Stormwater Coalition of Albany County

Storm System and Outfall Mapping

What Is an MS4 Outfall? Analysis & Diagrams

Questions, Answers, and Guidance (~2015 to 2018)

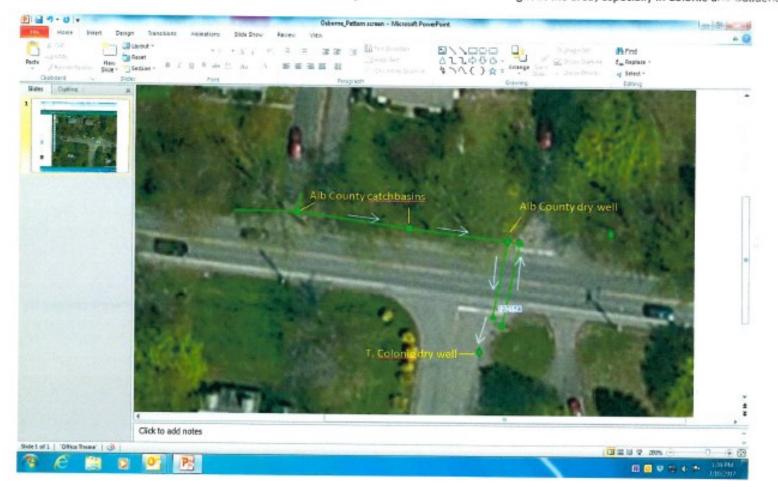
This is a screen capture image (from the Stormwater Coalition GIS webmapper) of a situation in which I am trying to determine if we have a true regulatory stormwater outfall (190154). The system consists of Albany County catchbasins on Osborne Road that ultimately drain to a dry well, which is believed to have an emergency overflow outlet that apparently is directed to a Town of Colonie structure on Patten Drive that I also believe to be a dry well. Second image is a zoomed out version with the Town infrastructure added for comparison. I looked at this in the field and the mapping appears to be correct as best as I can tell. The question I would pose is, given the fact that there is apparently no direct discharge to surface waters from either jurisdiction's system (but rather to groundwater via dry wells), is this still an outfall? In other words, does the mere existence of an intermunicipal connection make it an outfall regardless of the ultimate fate of the flow? There are probably a number of comparable situations to this throughout the area, especially in Colonie and Guilderland. Thank you,

If it's not hitting a surface water, which can be a wetland, then it's not an outfall. Sounds like it the dry wells are just to capture excess runoff which can then be infiltrated to groundwater.

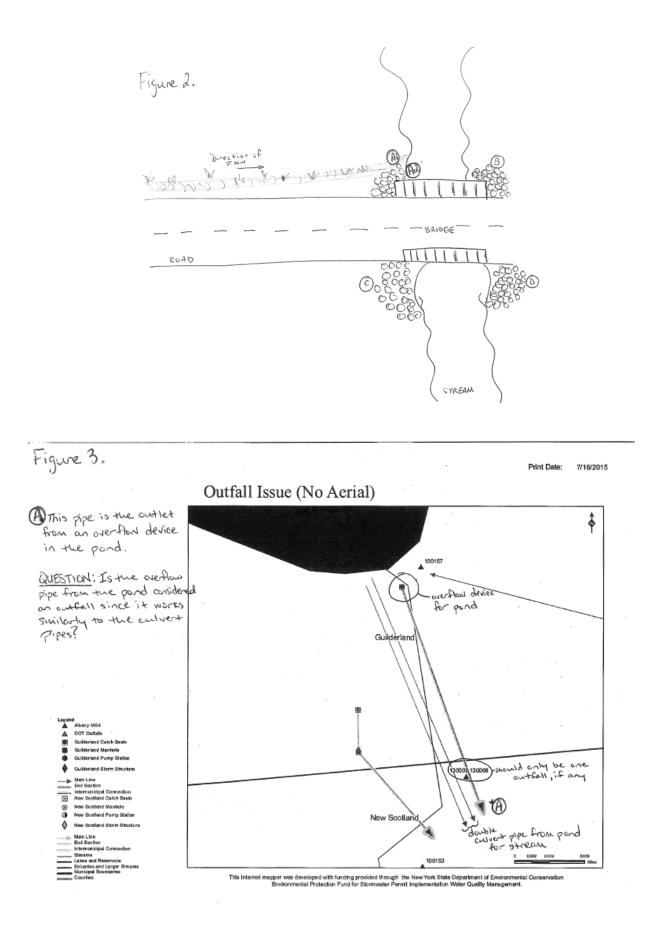
- a. *Figure 1a:* There was a bridge which has four 6" PVC pipes (A and B) going directly from the surface of the road into the culvert with the stream below. The stream will convey all of the stormwater from the road downstream (C).
- b. *NYS DEC Determination:* There are no regulated outfalls in this scenario. The structures in the bridge are not carrying concentrated flow (just sheet flow) and there is no real way to sample each of these structures as they discharge into the culvert below.

- a. *Figure 1b:* There was a bridge which has two catch basins (A and B) going directly from the surface of the road into the culvert with the stream below. The stream will convey all of the stormwater from the road downstream (C).

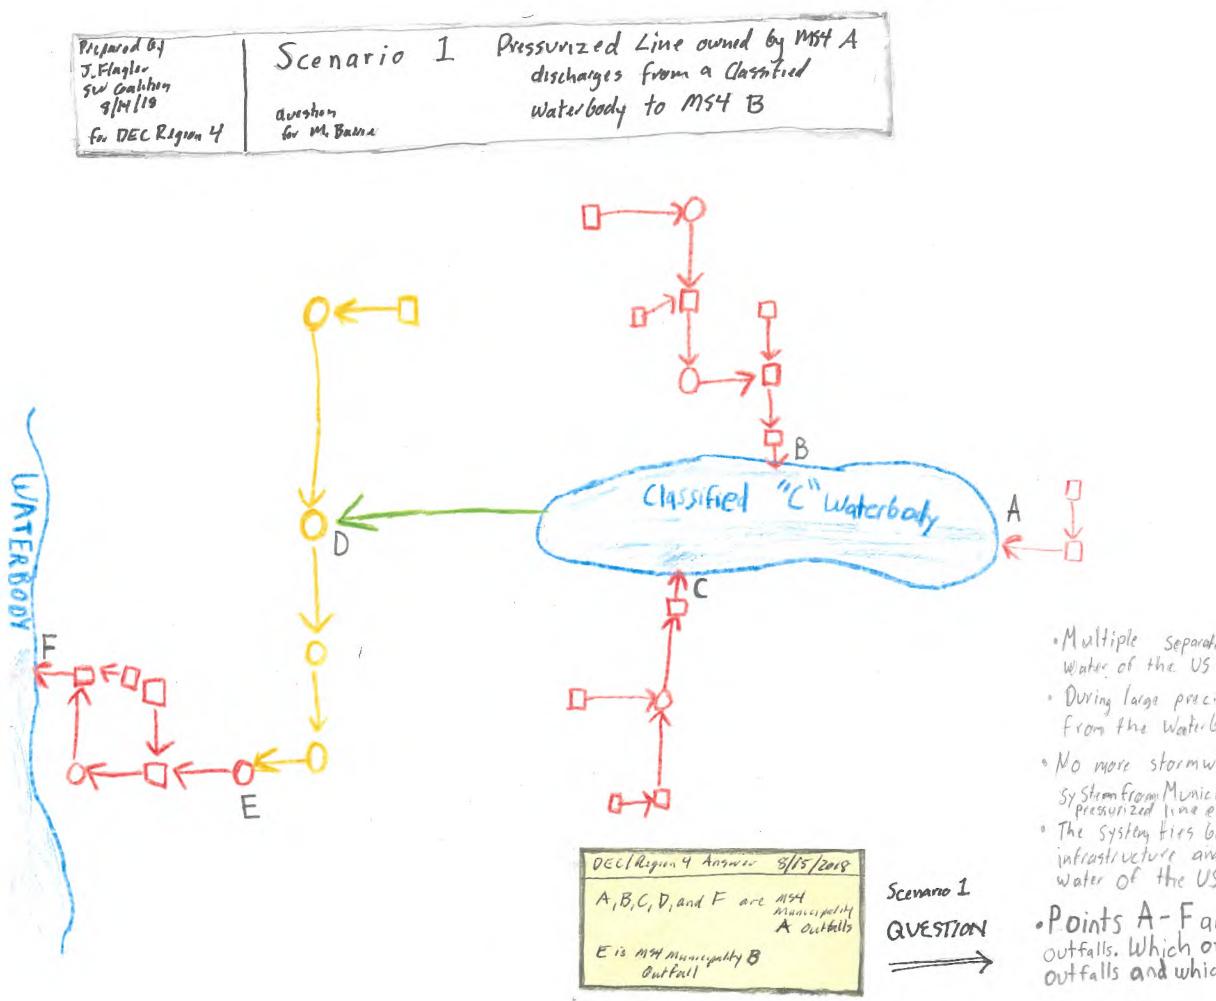
- b. *Another variation:* There are also similar situations in which a stream is piped underground, similar to a culvert, but under roads or parking lots, and there are catch basins from the surface going directly into the piped stream below. Would every catch basin be an outfall? None?

- c. *SWC Recommendation:* Per the previous NYS DEC recommendation, there are no regulated outfalls in this scenario. The structures in the bridge are not carrying concentrated flow (just sheet flow) and there is no real way to sample each of these structures as they discharge into the culvert below.

- d. *NYS DEC Determination:* There are no regulated outfalls in this scenario. The catch basins (A and B) in the bridge are not carrying concentrated flow (just sheet flow) and there is no real way to sample each of these structures as they discharge into the culvert below. Remember, outfalls are a way to sample the discharge, you are not sampling the stream (C).

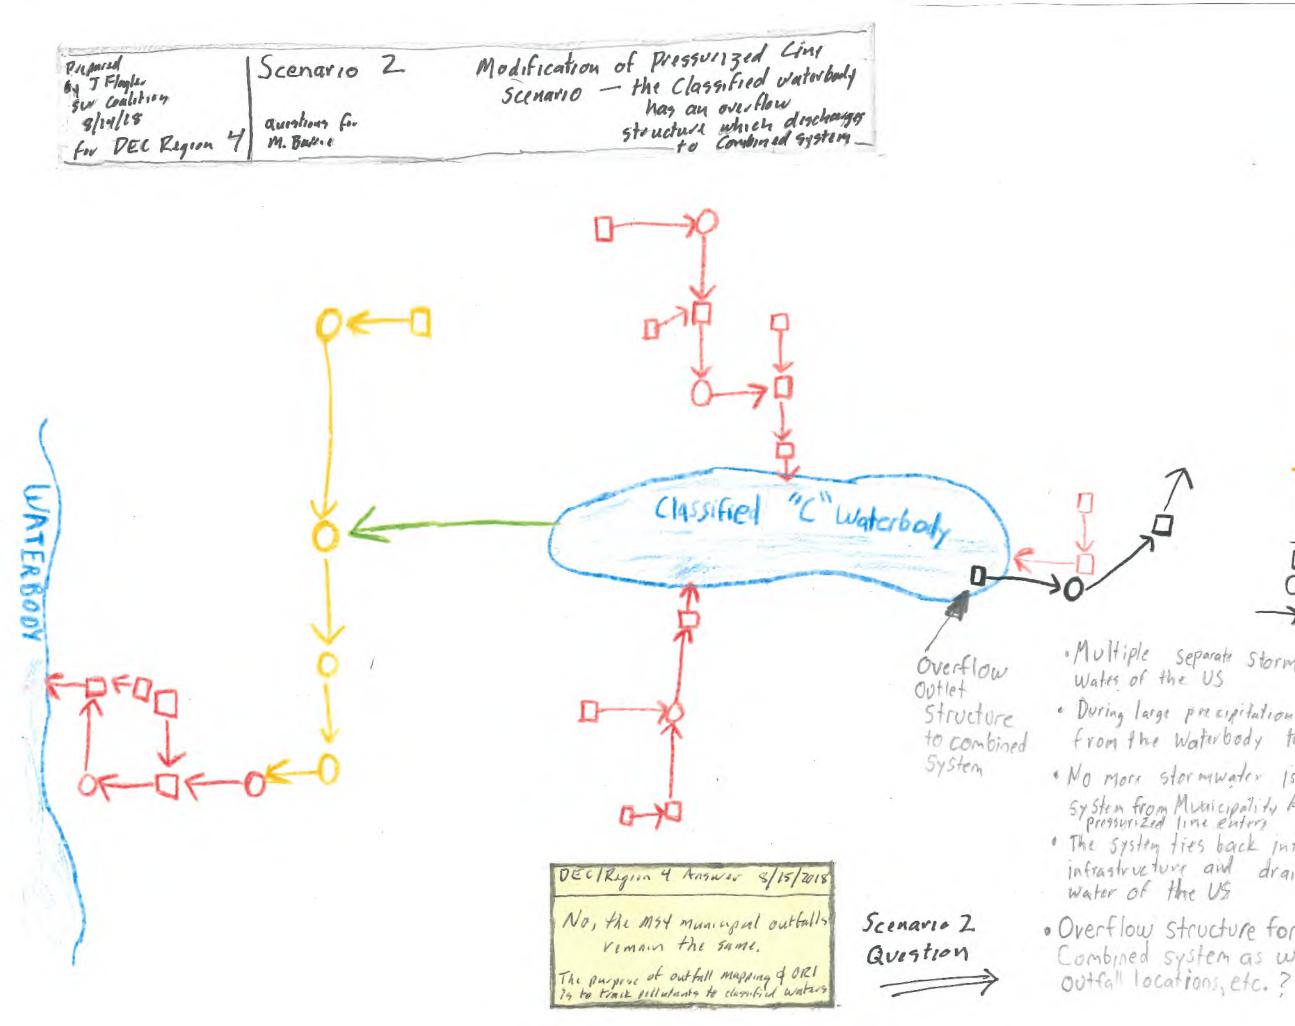
• Points A - Fare locations of potential outfalls. Which of these points are MS4 outfalls and which municipality do they belong to?
